EXHIBIT A

MONTICELLO NUCLEAR GENERATING PLANT
DOCKET NO. 50-263PROPOSED CHANGES TO TECHNICAL SPECIFICATIONS
APPENDIX A OF PROVISIONAL OPERATING
LICENSE NO. DPR-22

FIGURE 6.1.2 NORMAL FUNCTIONAL ORGANIZATION CHART

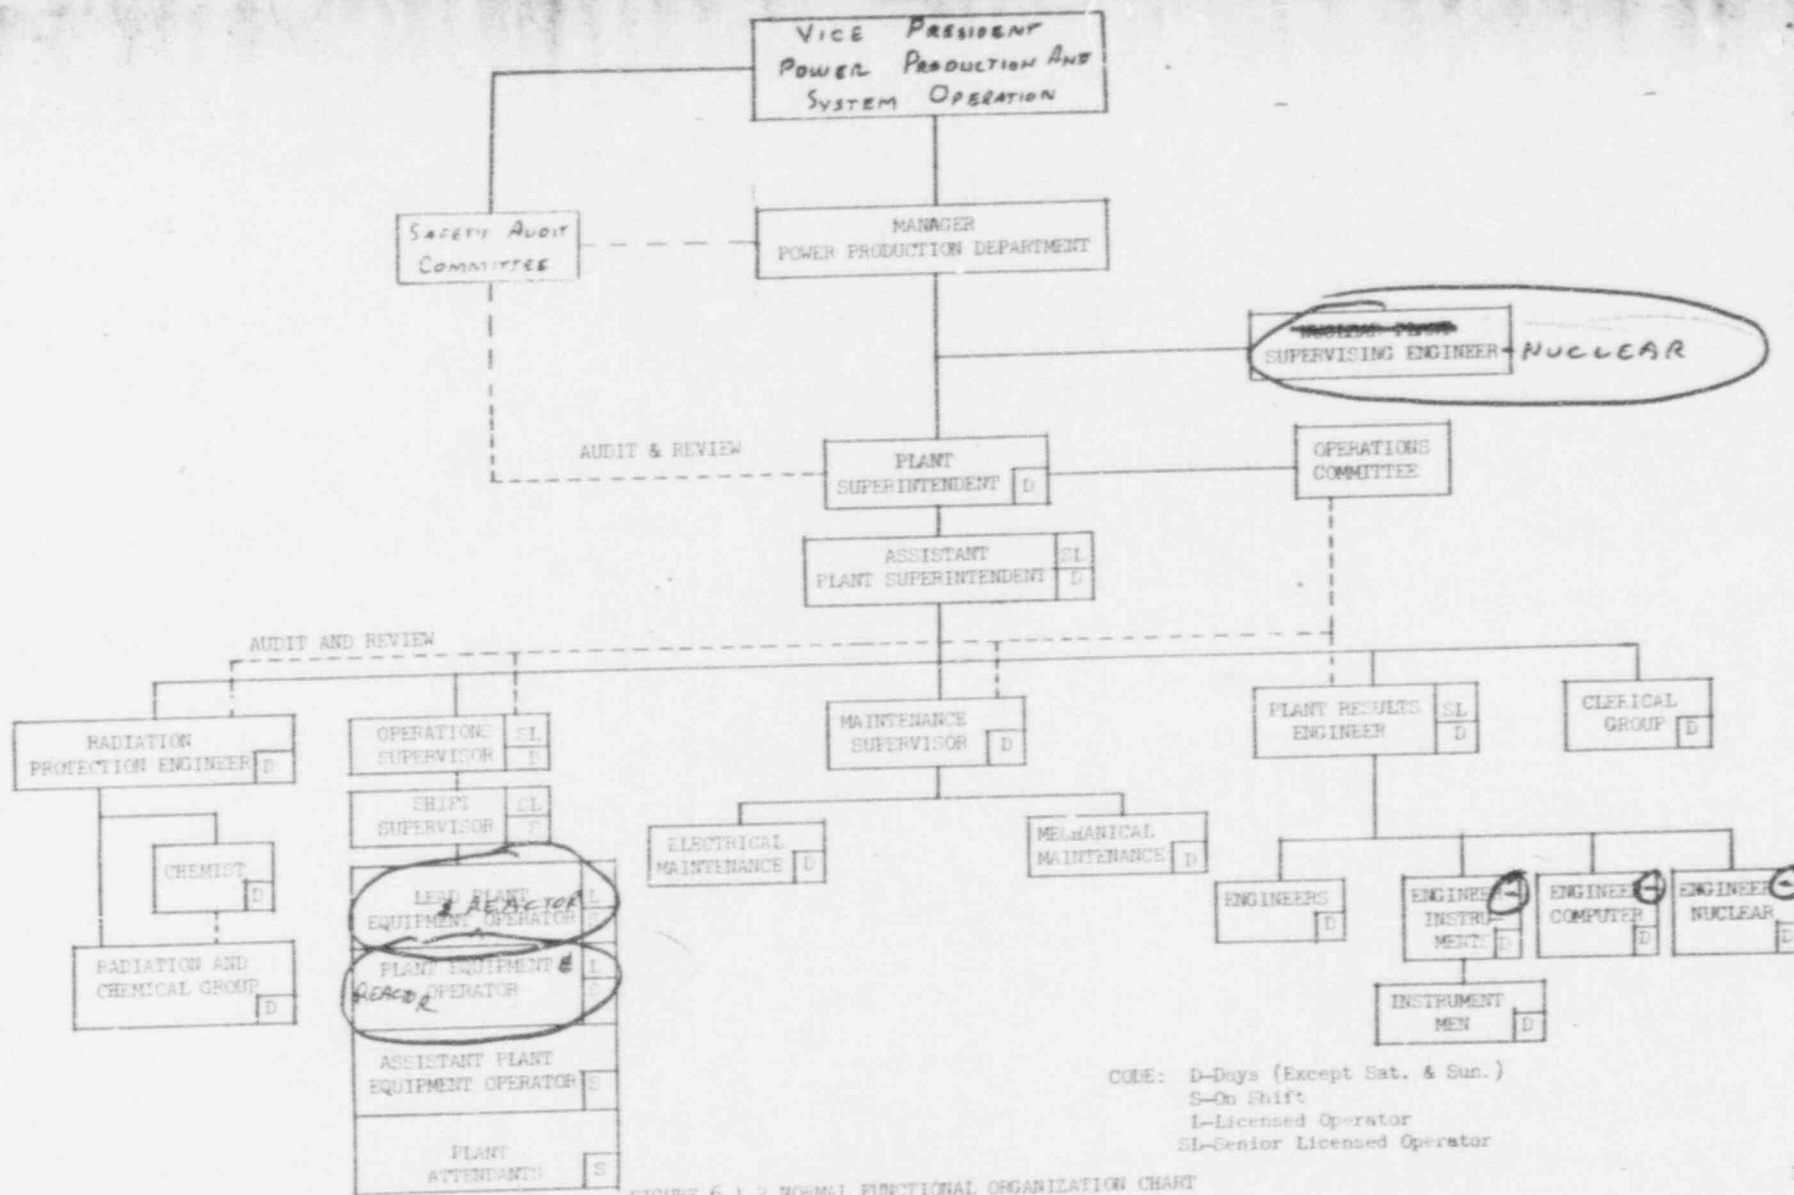
25. Page 194, Figure 6.1.2 Normal Functional Organization Chart

Add block for Vice President - Power Production and System Operation and change advisory function of the Safety Audit Committee from Manager of Power Production and System Operation to Vice President - Power Production and System Operation. Recent title changes are also made on the revised Figure 6.1.2 in Exhibit B attached.

Reason for change:

The change will make the organization chart consistent with the wording in the 6.1.E.1.e, Page 195.

FIGURE 3.4.1. Sodium Pentaborate Solution Volume
— Concentration Requirements

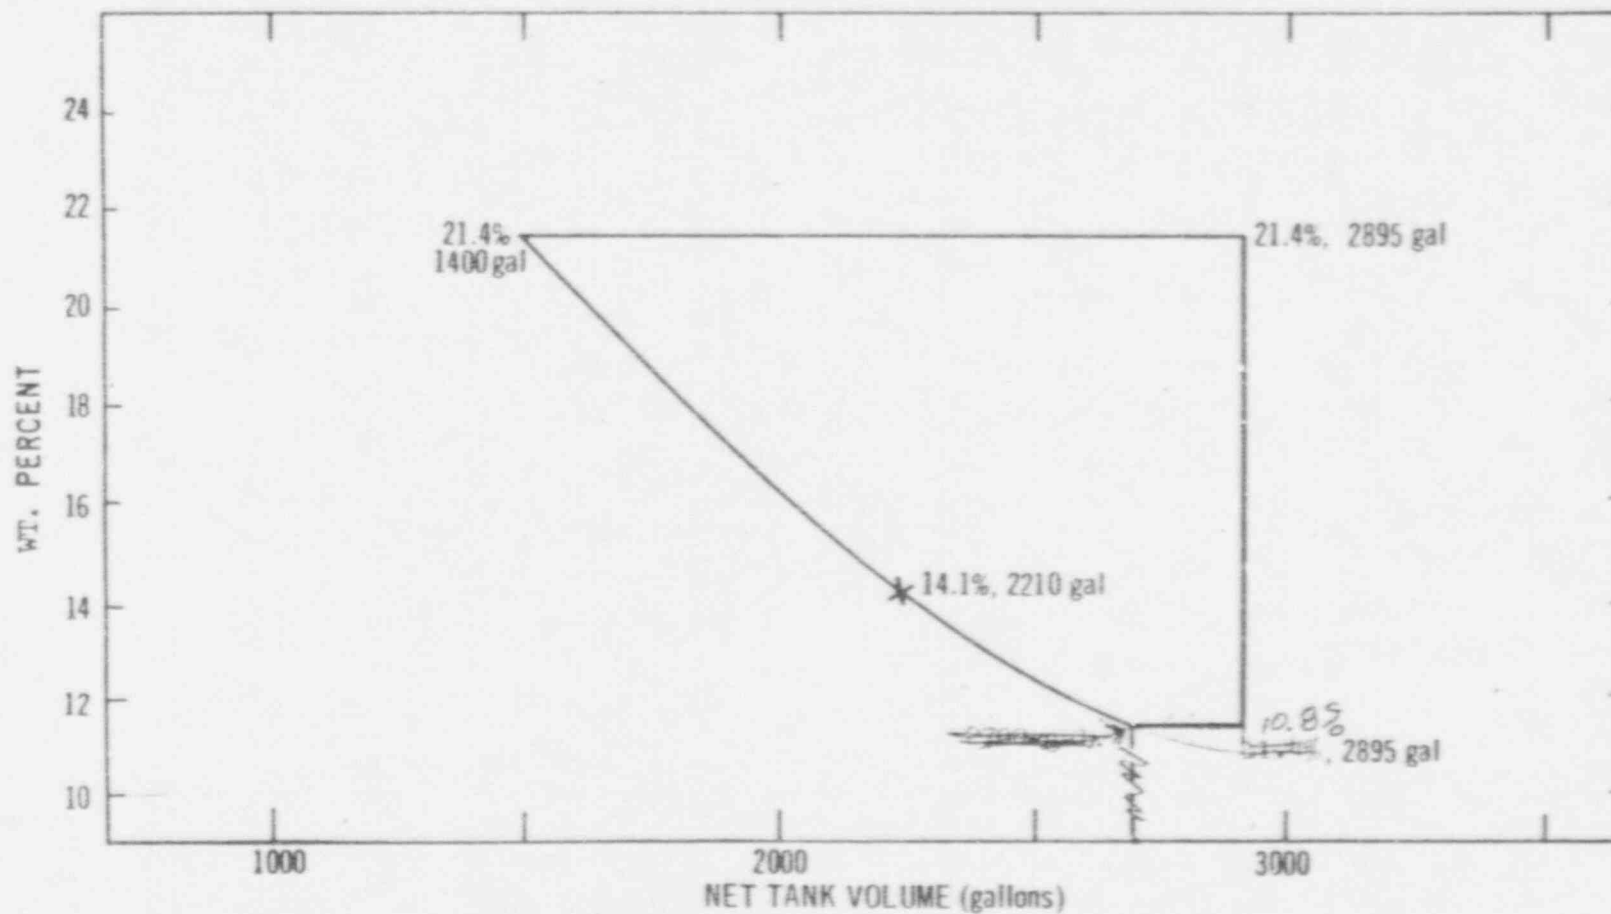
12. Page 92, Figure 3.4.1

Continue lower portion of curve to terminate at 10.8% at 2895 gallons.
Remove limit of 11.4% at \geq 2700 gallons.

Reason for change:

In one of the early draft versions of the Technical Specifications the bottom portion of the curve was removed to assure that the required amount of boron would be injected within 100 minutes at a minimum flow of 24 gpm. Subsequently, the requirements were changed. The present specification and bases require a minimum flow of 24 gpm and a pumping time not to exceed 125 minutes. Restoration of the lower portion of the curve is consistent with the present bases and will allow lower concentrations, thereby reducing minimum temperature requirements and reducing the possibility of crystallization.

FIGURE 2.1.1 FUEL CLADDING INTEGRITY SAFETY LIMIT

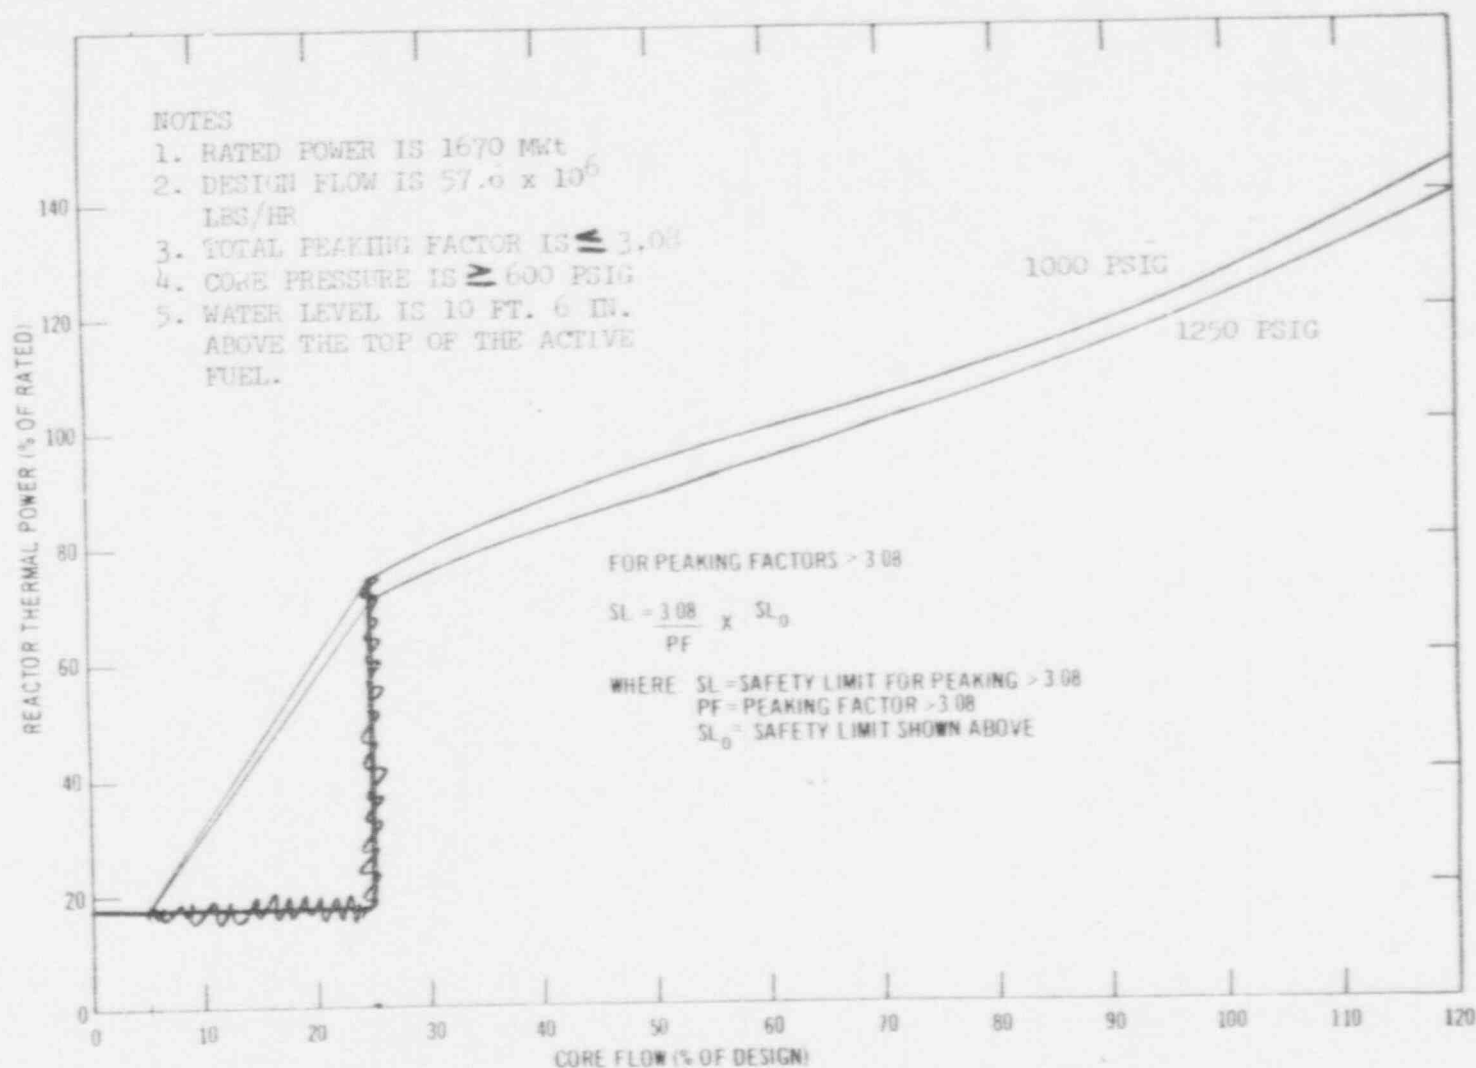
Page 10, Figure 2.1.1

Extend the two curves linearly from the present termination at 25% to 5% at 18% thermal power (300 MW).

Reason for change:

The basis given for fuel cladding integrity safety limits applies to the lower core flow limit of 5% but with less margin than the current lower limit of 25% flow. Following recirculation pump trip test at Monticello, the operating point was found to be close to the 25% flow limit line. The change will decrease the chance of a "technical" violation of the specification and will make the safety limit curve consistent with curves presently in use at other facilities.
